Access Compliance Report Public Rights-of-Way (Curb Ramps)

Main Street: CLYDESDALE_DR Cross Street: CLYDESDALE_DR Location: N

ADA ID: RPRK211110132206 Ramp Type: Type 1 - Perpendicular Initial Pass/Fail: Fail Overall Compliance: No Severity Score: 30

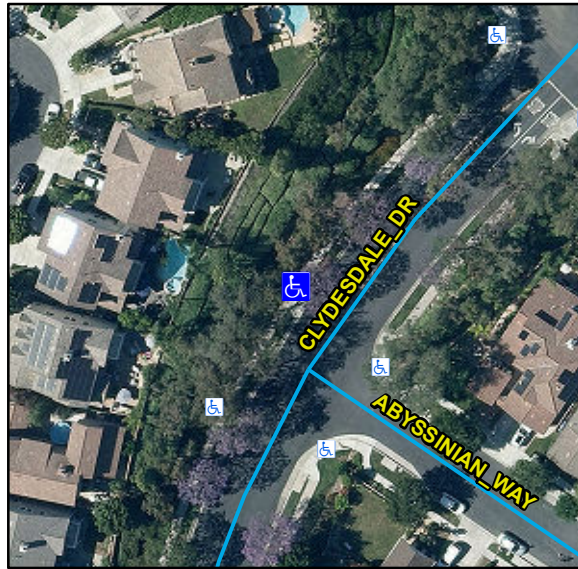
R304.2.2, R204.3, R304.5.3, STD 1115

Compliance	Description	Data	Compliance	Description	Data
N/A	Ramp Length (in)	68	N/A	Flare Type LT	
Yes	Ramp Width (in)	54			N/A
Yes	Ramp Run Slope (%)	5.4	N/A	Flare Slope LT (%)	N/A
No	Ramp Cross Slope (%)	7.5	N/A	Flare Traversable LT	N/A
N/A	Landing Present	N/A	N/A	Flare Type RT	
N/A	Landing Length (in)	N/A			N/A
N/A	Landing Width (in)	N/A	N/A	Flare Slope RT (%)	N/A
N/A	Landing Run Slope (%)	N/A	N/A	Flare Traversable RT	N/A
N/A	Landing Cross Slope (%)	N/A	N/A	DWS Provided	N/A
N/A	Landing Movement Obstructed?	N/A	N/A	DWS Contrast	N/A
	Landing Movement Type	N/A	N/A	DWS Length (in)	N/A
N/A	Landing Shared	N/A	N/A	DWS Full Width	N/A
N/A	Clear Space	N/A	N/A	DWS Offset Left (in)	N/A
N/A	Clear Space To Crosswalk (in)	N/A	N/A	DWS Offset Right (in)	N/A
N/A	Marked Crosswalk 1	No	N/A	Marked Crosswalk 2	N/A
	Crossing 1 Direction	SE		Crossing 2 Direction	N/A
	Marked Crosswalk 1 Width (in)	N/A		Marked Crosswalk 2 Width (in)	N/A

N/A	Ramp Inside Crosswalk 1	N/A	Yes	Ramp Inside Crosswalk 2	N/A
	Crossing 1 Slope (%)	4		Crossing 2 Slope (%)	N/A
	Crossing 1 Cross Slope (%)	7.1		Crossing 2 Cross Slope (%)	N/A
N/A	Gutter Ponding	N/A	No	Curb Slope	13
Yes	Gutter Lip Height (in)	0		Road Run Slope (%)	N/A
N/A	Gutter Run Slope (%)	N/A		Road Cross Slope (%)	N/A
N/A	Gutter Cross Slope (%)	N/A			
Yes	Overall Surface Condition: Acceptable		No	Perp Joint Present	No
	Cross Gutter Present?	No		Spandrel Present?	No
	Replace Cross Gutter?	N/A		Replace Spandrel?	N/A

Remove & Replace Entire Ramp.
